Preliminary Plat: Firdrona Drive

Application Numbers: 982712 and 982950
Parcel Numbers: 0222301019 and 0222301021

Gig Harbor Peninsula Advisory Commission (PAC) Public Meeting: July 13, 2022, at 6:30 p.m., at City of Gig Harbor, southeast entrance, 3510 Grandview Street, Gig Harbor, WA 98335

Proposal: The applicants request approval of a Preliminary Plat to subdivide two contiguous parcels, for a total area of 4.9 acres, into 16 single-family residential lots to be served by Peacock Hill Water, private road, a mix of on-site septic systems and a community septic tract, and stormwater management tracts.

Proposed Site Plan

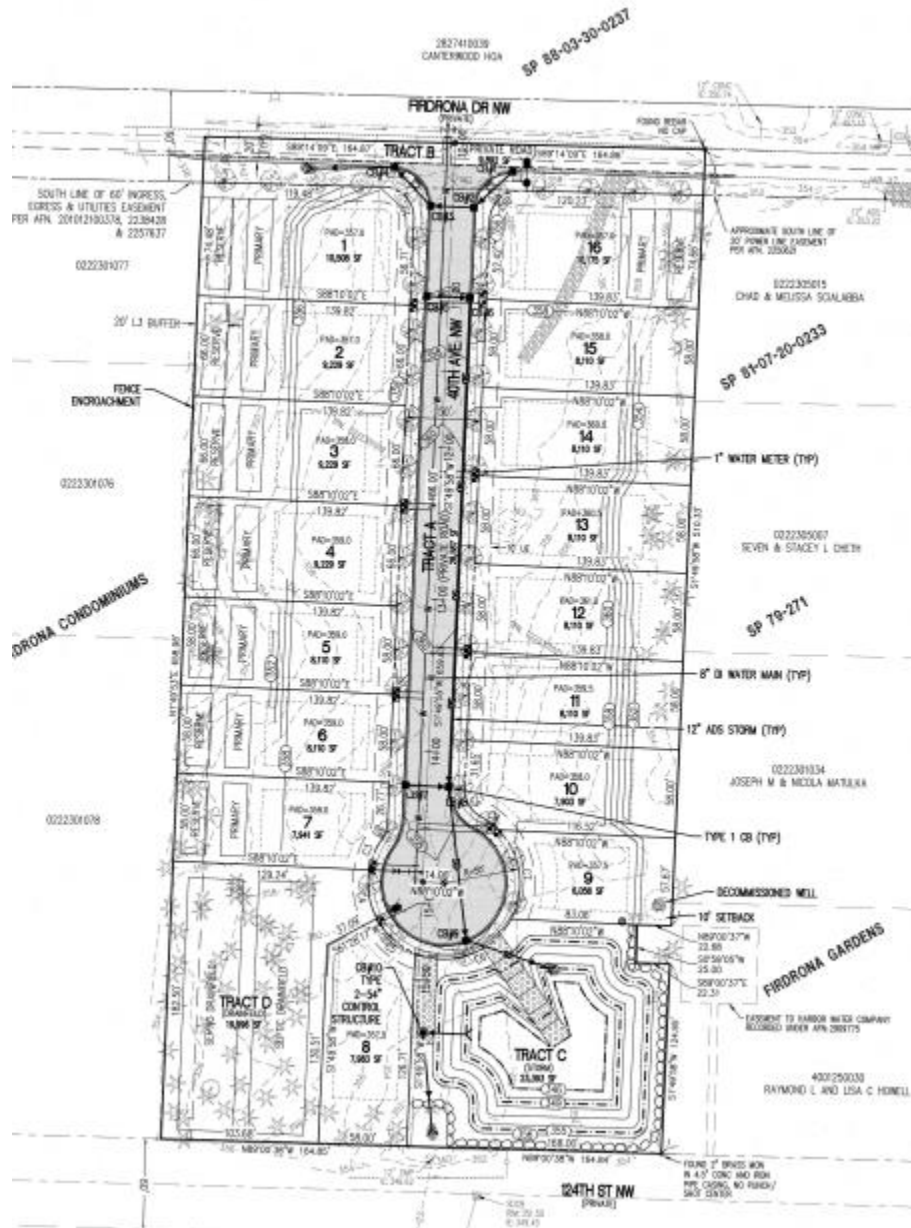
Staff Comment: Per Table 18J.15.030-2 “General Minimum Tree Unit Density” the proposal is within the Urban Residential area and requires that 30 tree units per net developable acreage be provided along with retention of 30% of the significant trees. The net developable acreage of this site is 4.09 acres which would require a minimum of 123 tree units to remain or be planted (4.09 acres x 30 tree units /ac = 122.7).

Based on the submitted site plan, there will be 244 tree units retained on the site, of which 73 are significant tree units. There are a total of 148 trees considered to be significant trees. As stated previously, per Section 18J.15.030.F.3, 30% of 148 significant trees, or 45 significant trees, must be retained on this site (148 significant trees x 30% = 44.4 significant trees). However, based on the submitted information, only 25 or 17% of significant trees will be retained which means the applicant must apply for a Site Plan Review (SPR) approval to deviate from the design standards. It is unclear from the tree retention plan which of the trees are the 148 significant trees. The applicant has been asked to clarify the location of those trees and provide a better legend on the site plan/tree retention plan to be submitted for the project.

In addition, staff has concerns with the legend on the submitted plan as it appears that the applicant is counting trees on the reserve drainfield areas of proposed Lots 1-7 and 16 as well as community drainfield Tract D to be retained where those trees will be removed for the original drainfield or a replacement in the future. An SPR may also be required if the applicant cannot meet the 244 tree units required by preserving trees on Lots 11-15 and by planting street trees.

Staff will require the applicant to place a note on the plat stating, “significant trees shown on the plat cannot be removed or replaced without approval of the Planning department.”

Staff Comment: The project site abuts single-family residences to the east and duplexes to the west. The applicant has shown the L3 buffer along the west property line of the Preliminary Plat.

Staff Comment: The Street trees are required at 1 per 30 lineal feet to be installed along the road frontage as well as all new and improved rights-of-way. The applicant has shown street trees along the north property line (Firdrona Drive NW) and both sides of Tract A (private road).
